Access Compliance Report

Public Rights-of-Way

Intersection ID: 54218	Main Street: GOLF_LINKS_DR	Cross Street: SANDY_ROCK_PL	Location: SW
ADA ID: 145AB8F7BBAB	Ramp Type: Directional1	Initial Pass/Fail: Fail	Overall Compliance: No
		Severity Score: 1.25

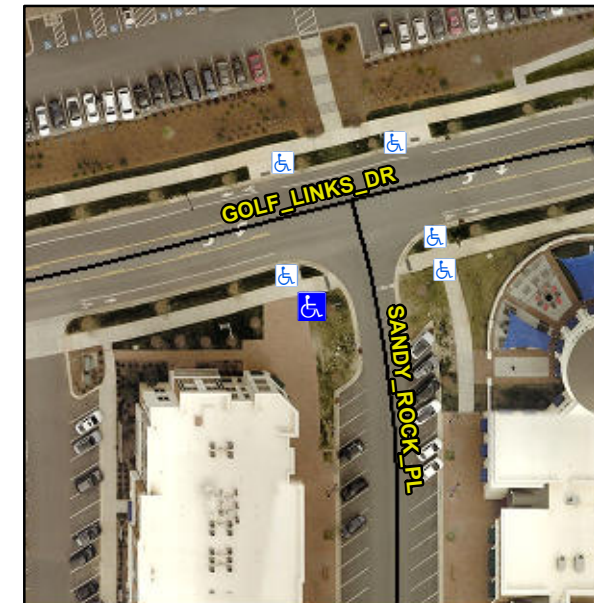
R304.5.3

Compliance	Description	Data	Compliance	Description	Data
N/A	Ramp Length (in)	100.0	N/A	Grade Break?	N/A
Yes	Ramp Width (in)	84.0	N/A	Grade Break Slope (%)	0.0
Yes	Ramp Slope (%)	5.7	N/A	Grade Break XSlope (%)	0.0
No	Ramp XSlope (%)	3.1			
N/A	Flare Type LT	N/A	N/A	Flare Type RT	N/A
N/A	Flare Slope LT (%)	N/A	N/A	Flare Slope RT (%)	0.0
N/A	Flare Traversable LT?	N/A	N/A	Flare Traversable RT?	N/A
N/A	Landing Length (in)	0.0	N/A	DWS Provided?	N/A
N/A	Landing Width (in)	0.0	N/A	DWS Contrast?	N/A
N/A	Landing Slope (%)	0.0	N/A	DWS Length (in)	N/A
N/A	Landing X Slope (%)	0.0	N/A	DWS Full Width?	N/A
N/A	Landing Curb? (Y/N)	N/A	N/A	DWS Offset LT (in)	N/A
N/A	Shared Landing?	N/A	N/A	DWS Offset RT (in)	N/A
N/A	Gutter Ponding?	0.0	N/A	Gutter Slope (%)	N/A
N/A	Gutter Lip Ht (in)	0.0	N/A	Gutter X Slope (%)	N/A
N/A	Painted X Walk1?	No		Road Slope (%)	1.1
	X Walk 1 Direction	To E		Road X Slope (%)	2.9
	X Walk 1 Width (in)	N/A		Clear Space?	N/A

Remove & Replace Entire Ramp.
